UNITED STATES PATENT AND TRADEMARK OFFICE

Office Action Summary	Application No. 10/781,527	Applicant(s) KATZ, EDWARD R.	
	Examiner Mark R. Wendell	Art Unit 3609

DETAILED ACTION

McNally Figure 3

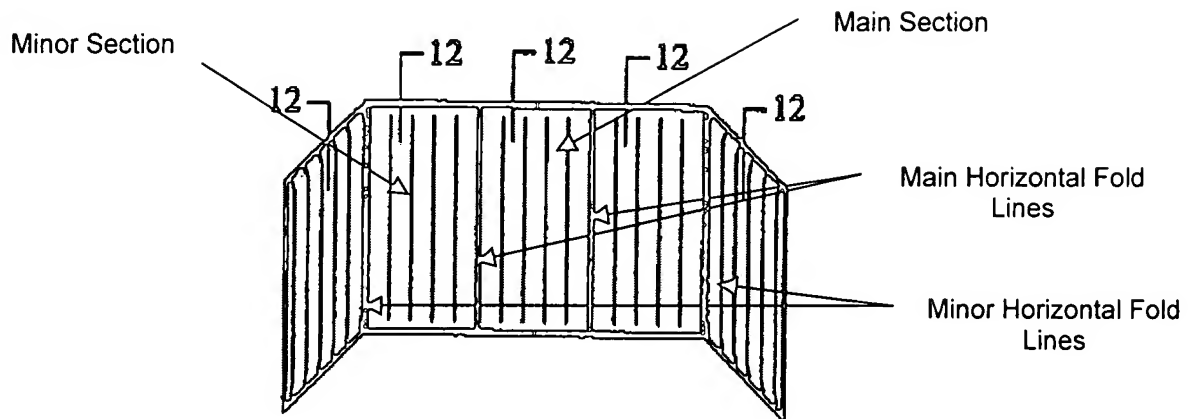
- A main section (12) with the main protection material comprising a cushioning material (air) and at least one rigid sheet in juxtaposition to the cushioning material;
- A main section having a horizontal fold line (see modified figure below) with a cushioning material (air) and a portion of the sheet on each side;
- A minor flap, with a horizontal fold line, composed of a least one material rotatably connected to the main section;
- A noninvasive, detachable, securing system capable of securing the device to the protected surfaces (loops on all corners in Figure 2).

The examiner also notes that the main section and minor flap are capable of being folded along the horizontal fold lines for portability (Figures 2 and 3 of McNally).

Regarding claim 2 and 3, the device of McNally is foldable about the corner, or about the width of a door, as shown in Figures 2 and 3.

Regarding claim 5, McNally illustrates in Figure 3 (shown above) the main section having two rigid sheets on each side of the fold lines.
